Architectural Review Committee Staff Report Meeting Date: March 18, 2024

PETITIONER: The Ridge Group (TRG)

PETITION: Kensington Gardens Apartments Product Approval

Exhibit A (Site Plan)

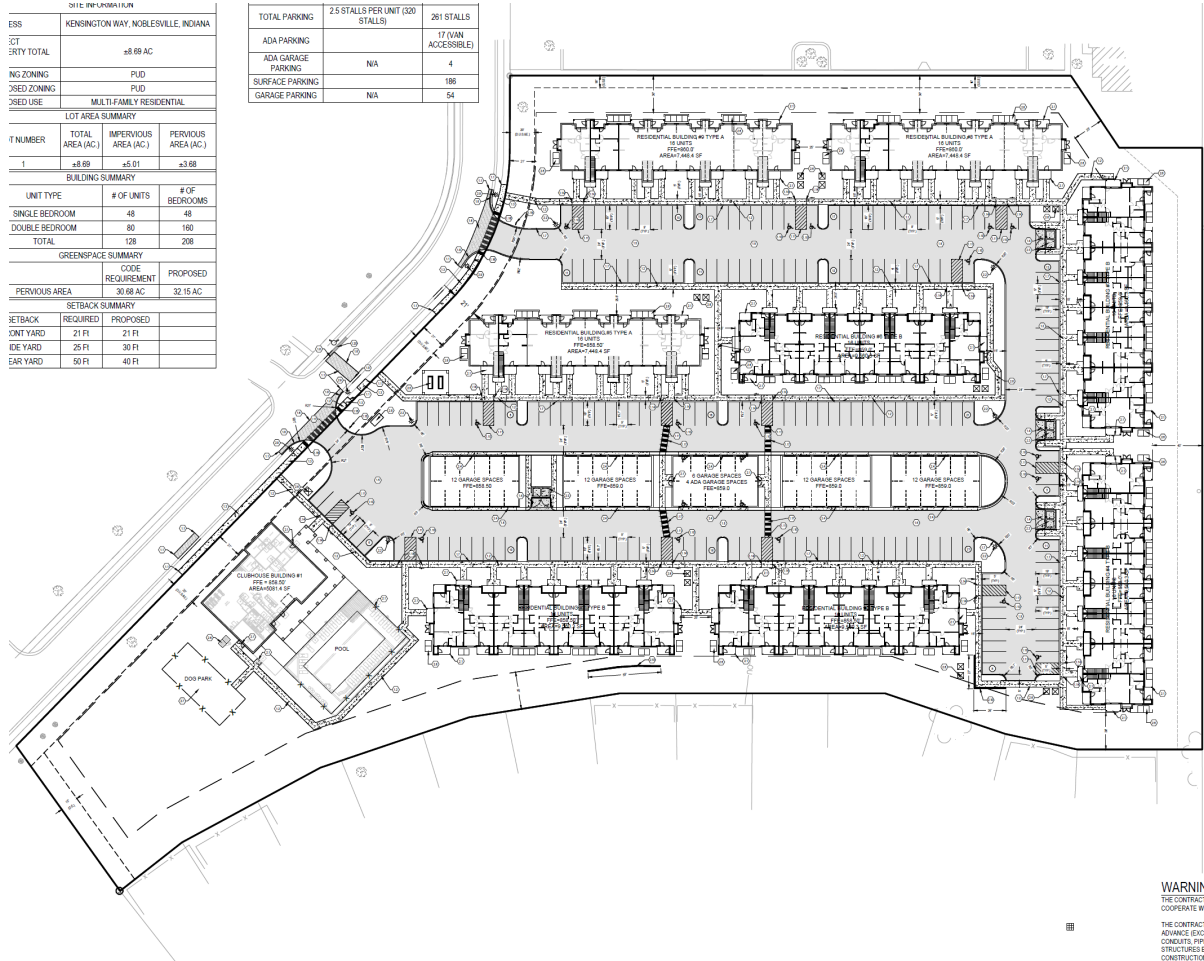
STAFF REVIEW: A total of 128 apartment units, within 8 buildings are proposed (16 units per building). In addition, the project includes garages, a clubhouse/amenity area, and mail kiosk. All buildings will use the same color brick, and will stay within the overall color scheme, as proposed.

At the outset of the project, one of staff's requests was for the proposal to include buildings that provided some consistency with the existing apartment buildings, while also updating and upgrading some aspects. The petitioner has maintained consistency by keeping a similar building massing, height (2-stories), and architectural style, while making upgrades primarily in terms of the color scheme and using fiber cement siding instead of vinyl.

Staff finds the proposal meets the applicable requirements and recommends approval of the petition.
